**Subject: Response to NRC Comments on the Draft Airborne Radiological Survey for  
Fort McClellan**

**Response to Comments by the U.S. Nuclear Regulatory Commission  
on the Airborne Radiological Survey – Main Post and Pelham Range  
Fort McClellan, Calhoun County, Alabama**

*Comments from Thomas R. Decker, Chief, Materials Licensing/Inspection Branch1, excerpted from NRC Inspection Report No. 01-02861-05/03-01, dated August 25, 2003.*

**Response to NRC INSPECTION REPORT NO. 01-028161-05/03-01  
Airborne Radiological Survey of Main Post and Pelham Range,  
Ft. McClellan, Alabama**

Figure 3-1

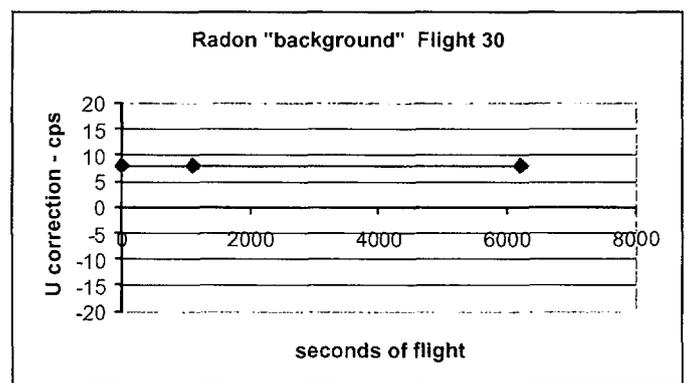
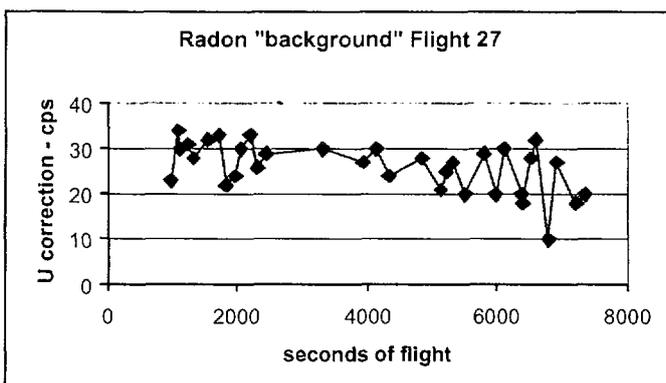
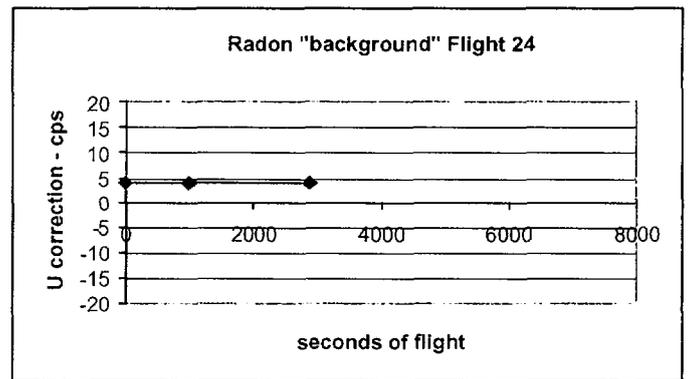
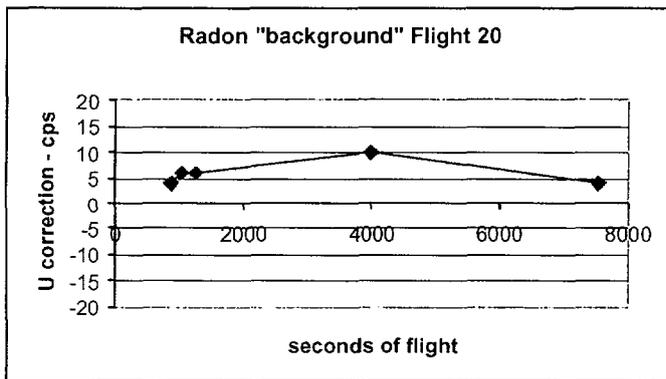
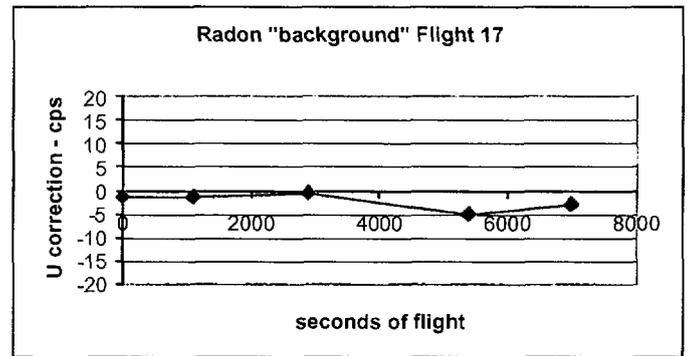
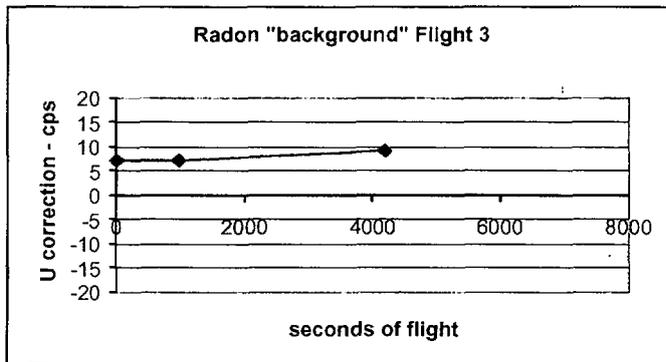
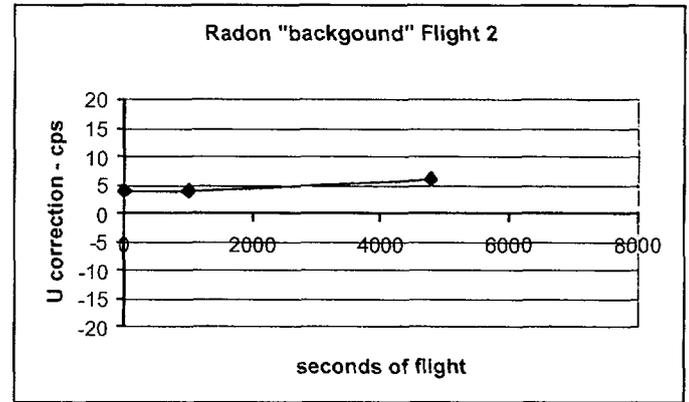
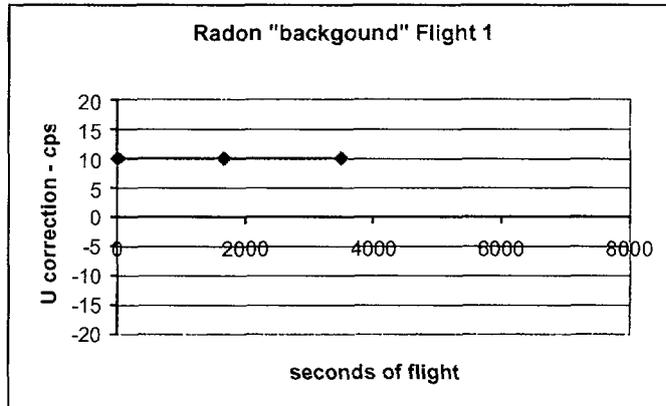
**Comment 4:** Discussion in the report indicates that radon background measurements could not be performed because there were no upward-looking detectors utilized during the survey. Radon banding was observed in the uranium window and to a lesser extent in other windows and was adjusted to base levels to match local backgrounds on a line by line basis. According to the report, this correction may cause errors in defining absolute background and concentration values, but does not affect identification of point source anomalies. Please provide additional information regarding this stripping technique, particularly a reference, to allow for validation of this conclusion.

The effect of radon in the Ft. McLellan survey was observed as banding in the uranium window and to a lesser extent in the total count and low/high energy windows. The effect of the radon on the measured count rates was minimized through adjustment of base levels or long wavelength adjustments on a line-by-line basis to match local backgrounds. This sort of DC shift or 1<sup>st</sup> order correction is similar to that which would be applied from measurements of background over water at the start and end of every flight and will not have a detrimental effect on the ability to detect point source anomalies.

In an attempt to identify only those flights that require background adjustment, the count rates from the repeat test line were reviewed. Repeat measurements over the Ft. McLellan survey test line allow for the demonstration of differences in survey conditions which are likely due to radon variation for specific flights. Under the assumption that the test line is flown at the same altitude and starts and stops in the same place each day, variation in the average daily count rates in the uranium window in particular, will be primarily due to the presence of radon background. This procedure was used to identify flights that might contain elevated radon backgrounds during the Ft McLellan surveying. Average Uranium counts for the test line are plotted against average Thorium, Potassium and Total Count channels – an example of which is shown in Figure 3-1 for Thorium versus Uranium. From this analysis, flights 2,3,17,20,24,27,29 and 30 in particular, are seen to have elevated average count rates in the Uranium window.

**Figure 3. Fort McClellan Pelham Range P4 Anomaly – Shale Outcropping**

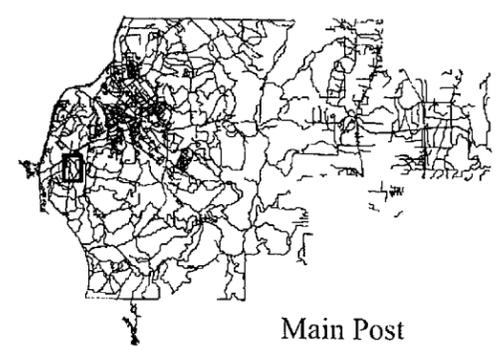
**Comment 7:** Anomaly P4 had elevated Co-60 in addition to elevated exposure rate, unlike P3 and P5 through P10, which only exhibited elevated exposure rates. The P4 ground investigation exposure rate measurement was significantly greater than other shale outcropping anomalies. In addition, the exposure rate at the surface was nearly two times the one-meter measurement, compared to the other anomalies where the exposure rates did not significantly change with distance. During the M2 anomaly ground survey, the hand-held NaI spectrometer drifted and incorrectly identified Cs-137 in the spectrum. Because of the exposure rate results and potential for misidentification, or non-identification, for the P4 anomaly, please provide additional information supporting your conclusion that the elevated readings in this area were due to the shale outcropping.

Surface exposure rates ranged from 8 to 42 microroentgens per hour ( $\mu\text{R/hr}$ ) with the higher exposure rates being associated with extensive visible shale outcroppings at anomaly P4 (see Figure 3). One-meter exposure rates ranged from 5 to 21  $\mu\text{R/hr}$ , again, with the higher exposure rates recorded at the P4 anomaly.
